Planning Inspectorate Inquiry.

Application by Photovolt Development Partners (PVDP) on behalf of SolarFive Ltd for an Order Granting Development Consent for the Botley West Solar Farm project.

Name of contributor: Professor David Rogers

The planning balance of the costs and benefits of the proposed Botley West Solar Farm.

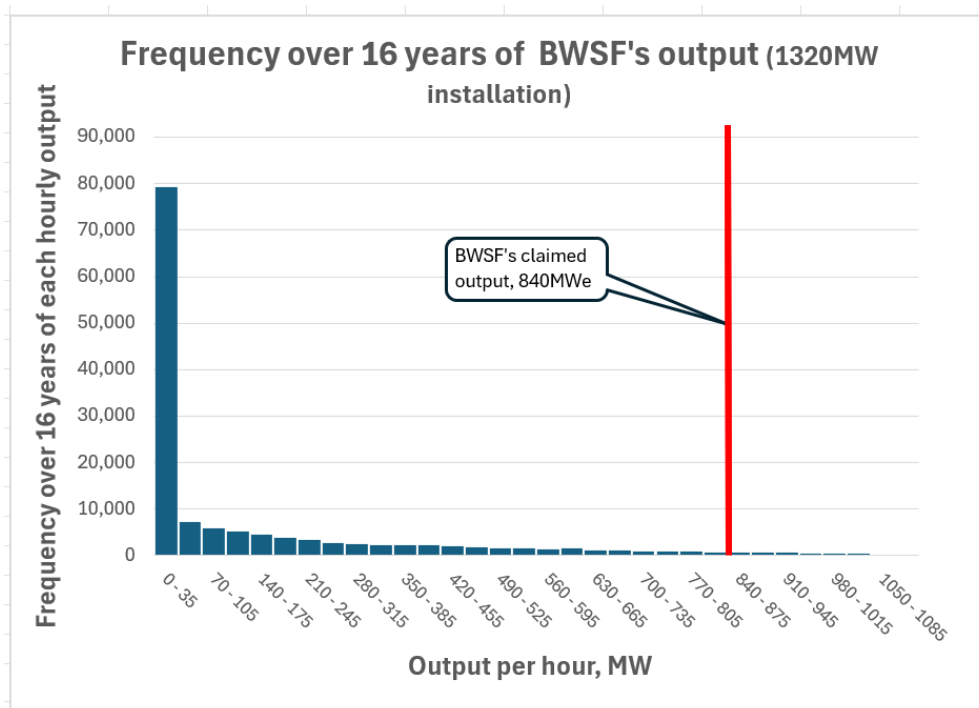
At both capacities, the output is less than 35MWe for more than half of the time. This is less than one twentieth of the applicant's claimed output of 840MWe, a value that is met or exceeded on average for only 2.3% of the time in a 1320MWp installation and for only 0.4% of the time in an 1100MWp installation (Figs 1 and 3 respectively).

The applicant simply cannot claim that the output from BWSF will be 840MWe of electricity when this value is reached for less than 3% of the time on average in a 1320MWp installation or less than 1% of the time in an 1100MWp installation. In any other branch of industry or commerce such false advertising would be sanctioned³.

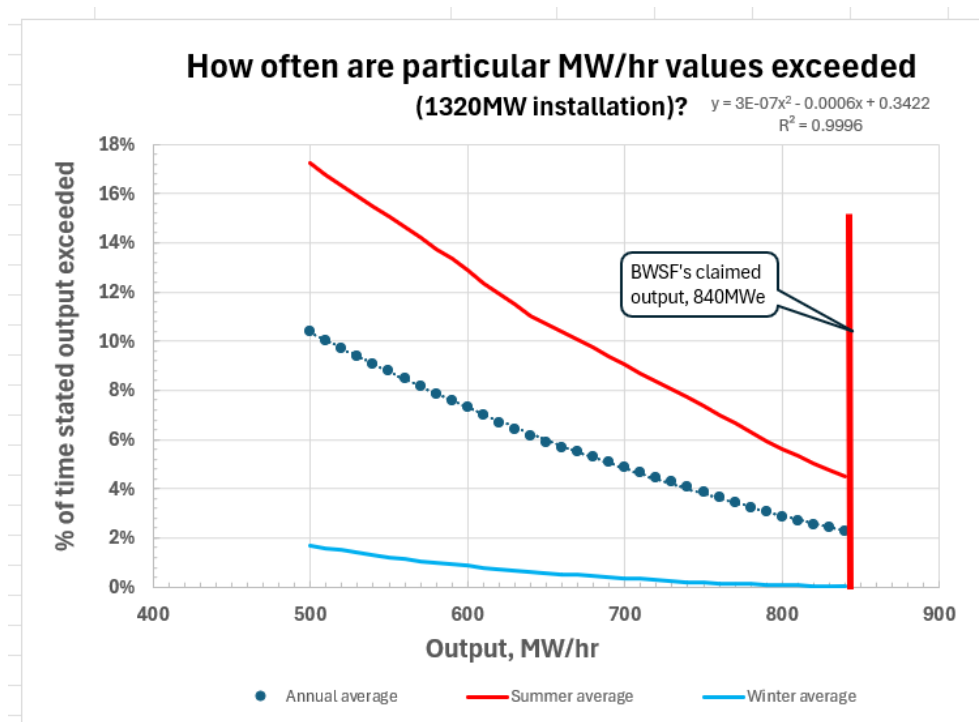
Figs 2 and 4 show the seasonal variation at the higher levels of MWe, with values in a 1320 MWp system reaching 840MWe for only 4.5% or 0.3% of the time in Summer and Winter respectively (Fig. 2) or for only 0.87% or 0.00% of the time in an 1100MWp system (Fig. 4).

Figure 5. The power consumption (y-axis) and size (x-axis) of four of the UK's largest data centre (blue points, regression line) from which we can estimate the likely power consumption of EXOq – i.e. 61.2MWe, the red dot in this Figure.

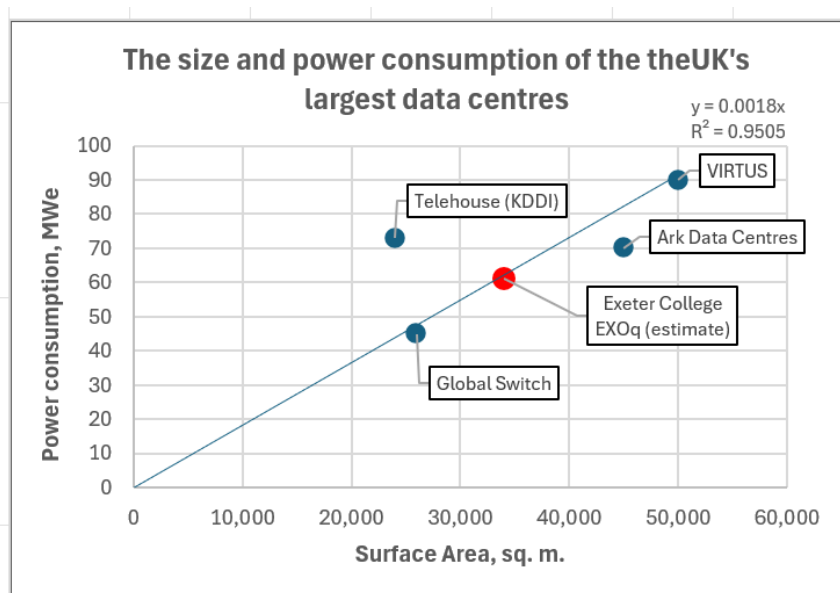
Figure 5 shows the relationship between the power consumption (MWe, y-axis) and area (x-axis) of four of the UK's largest data centres⁶ (blue points) from which we can estimate the power consumption of EXOq, based on its area of 34,000 sqm (the red point in Fig. 5), as likely to be c. 61.2MWe – between the rather wide limits of 50MWe+ to 100MWe mentioned in the CDC planning documents.

Taking the worst-case scenario of 100% continuous power consumption, a 61.2MWe data centre will require 536,112MWh of electricity each year ($= 61.2 \times 24 \times 365 \text{MWh p.a.}$).

If an 1100MWp capacity BWSF provided all of this electricity it would amount to more than half (51.1%) of its entire annual output of 1,048,788 MWh (from the third column in Table 1, above) and would reduce the number of homes supplied by BWSF's power from 281,101 to 137,410. That is, EXOq would take up all the electricity required to power 143,691 homes each year, equal to about half of Oxfordshire's entire household number (288,108 in the ONS 2021 census⁷).

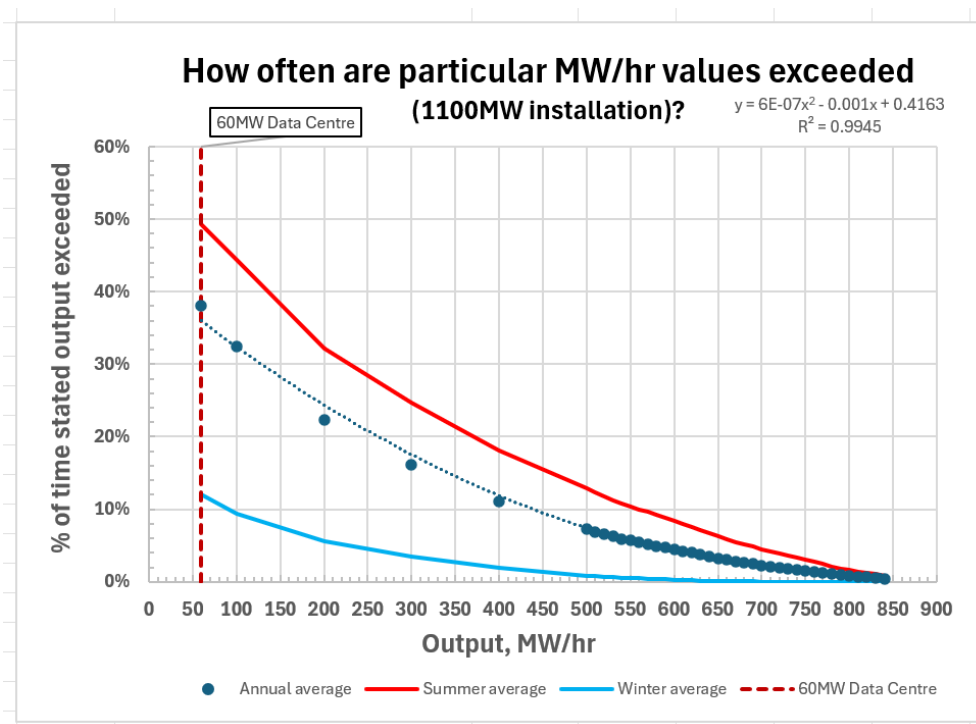
Figure 6 extends Figure 4's output characteristics of an 1100MWp installation to the 60MWe power requirements of a data centre. The 60MWe requirement is shown by the vertical dashed line. The Figure shows that even if EXOq had 'first call' on BWSF's power output, the latter could supply 60MWe (or more) for only 38% of the time on average; 49% in Summer but only 12% in Winter. Without considerable battery storage facilities (not proposed for BWSF and mentioned only in the form of presumably shorter-term UPSs in the Exeter College application), it is unclear how EXOq could be powered entirely by renewable energy (a gas-powered generator is proposed for the EXOq Energy Centre next door to, but quite separate from, the HPC centre).
